ADVISORY
 BULLETIN

No. 99-2

Propeller Whine – 25 Thru 50

New Series Propeller with Chisel Point Trailing Edge

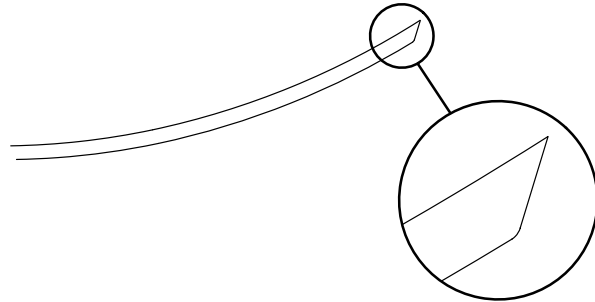
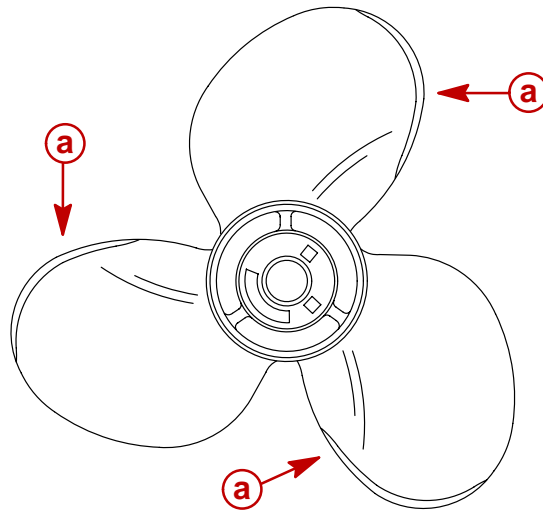
We have experienced propeller whine on the models listed that require 8, 9, or 10-1/2 inch pitch propellers. Propeller whine is difficult to describe and does not occur with all applications. The propeller whine referred to in this advisory is caused by propeller blade vibration, creates a mid to low noise, and usually occurs between 1200 and 2400 rpm. It will not affect gear or gearcase durability. Most of the reports involve these models on pontoon boat applications with 8, 9, and 10 inch pitch propellers. Propellers that whine on one application can be removed and installed on another application or on a different gear ratio outboard and not produce the noise. The same style 3.44 in./87.38 mm diameter gearcases with a 2:1 gear ratio have not experienced this noise situation.

It is recommended to install the new series propeller that has the trailing edge tapered in the form of a chisel point.

You can identify the new propellers by inspecting the propeller blade trailing edge. The taper begins 3/16 to 1/4 in. (5 to 6 mm) in from the edge and finishes to a fairly sharp point at the very trailing edge of the prop blade.

a - Blade Modified Area
Front View

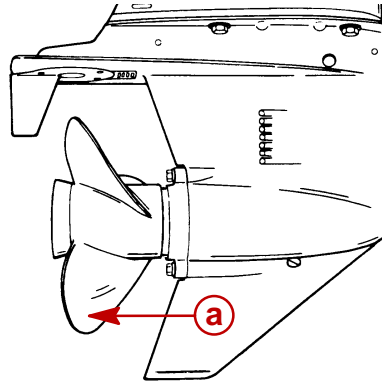
The area of the taper begins approximately 2 in. (50 mm) from the prop hub and extends around to the tip of the blade.
